SUBJECT: SAN ONOFRE 1 - SEP TOPIC XV-9, STARTUP OF AN INACTIVE LOOP OR RECIRCULATION LOOP AT AN INCORRECT TEMPERATURE, AND FLOW CONTROLLER MALFUNCTION CAUSING AN INCREASE IN BWR CORE FLOW RATE

Enclosed is a copy of our final evaluation of SEP Topic XV-9 for San Onofre Unit 1. This evaluation incorporates comments from your letter of June 30, 1981 and has been rewritten in the standard SEP topic format.

TOPIC XV-9 STARTUP OF AN INACTIVE LOOP

SAN ONOFRE 1

Figure 1
 Transient Response for Startup of an Inactive Loop With Full Temperature Decrease

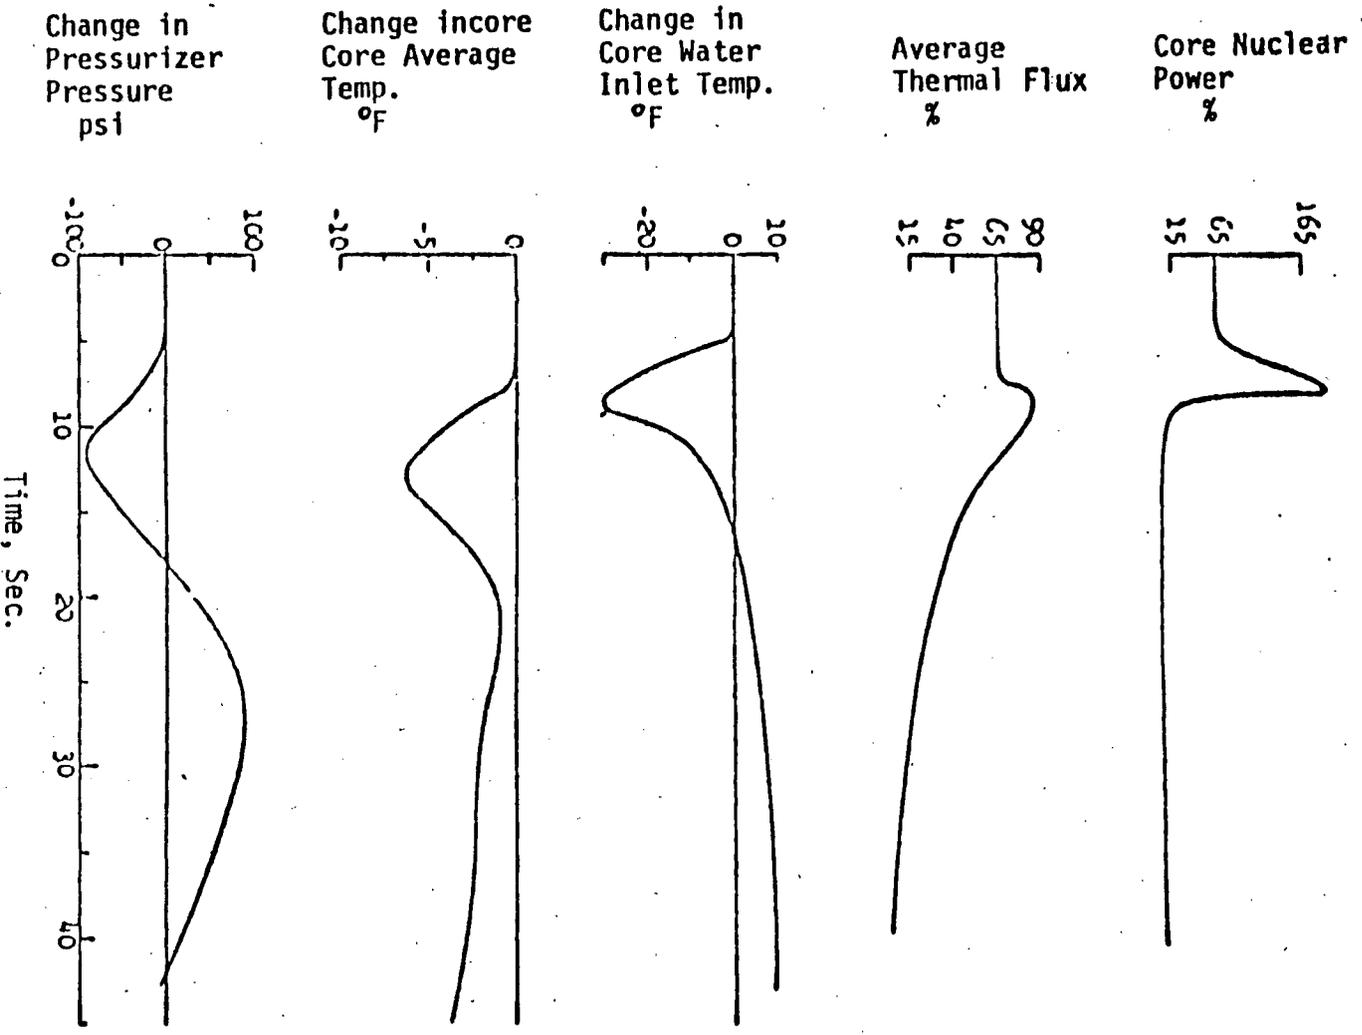
The peak nuclear power of approximately 185%, based on Figure 1 is reached in about eight seconds. Thermal flux of about 85% is reached. The reactor trip is from overpower at 100 %. The licensee believes this is a conservatively high value since the overpower trip at this power level would be set to give a maximum trip level of 80% of full power.

Since the peak thermal power is less than full power and the inlet temperature is less than the full power value there is margin to DNB. The minimum DNB ratio is 3.1 and occurs at about 10 seconds.

Figure 2
 Transient Response for Startup of an Inactive Loop Without
 Full Temperature Decrease

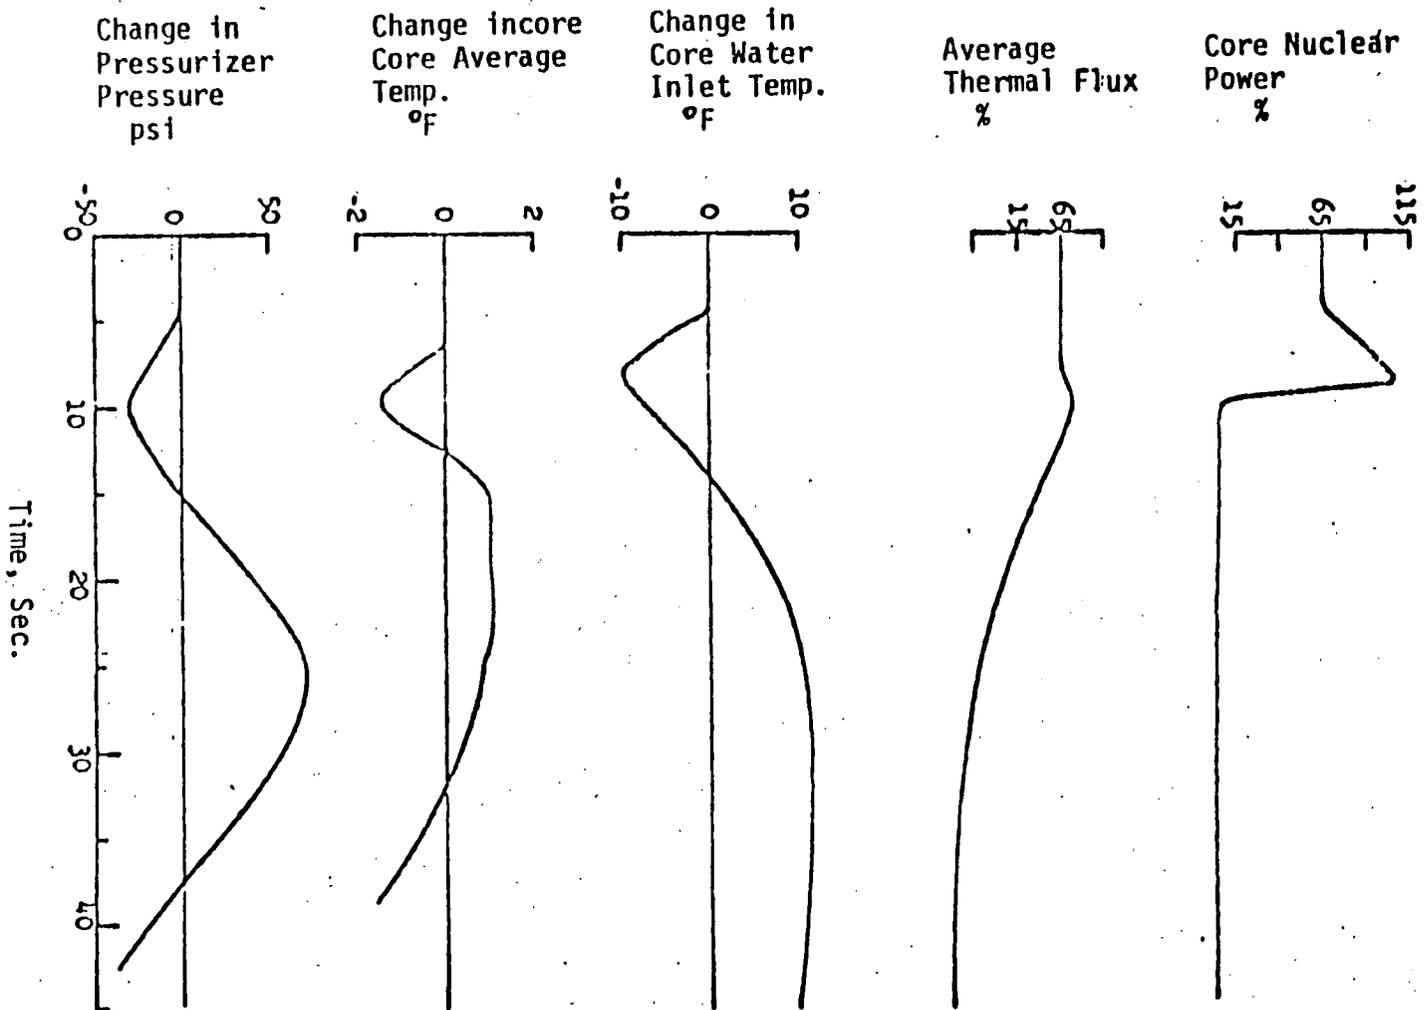
Figure 2 shows the effect of flow mixing with the active loops. The temperature change at the reactor vessel inlet plenum then becomes -12°F instead of -37°F . All other parameters are identical to those for the transients shown in Figure 1. In the case of the reduction of flow mixing with the active loops the pressurizer's pressure peak is significantly reduced. The actual transient would lie somewhere between the two results and would most likely be represented by the results which assume flow mixing. The results also show that the change in pressurizer pressure is less than 100 psia.
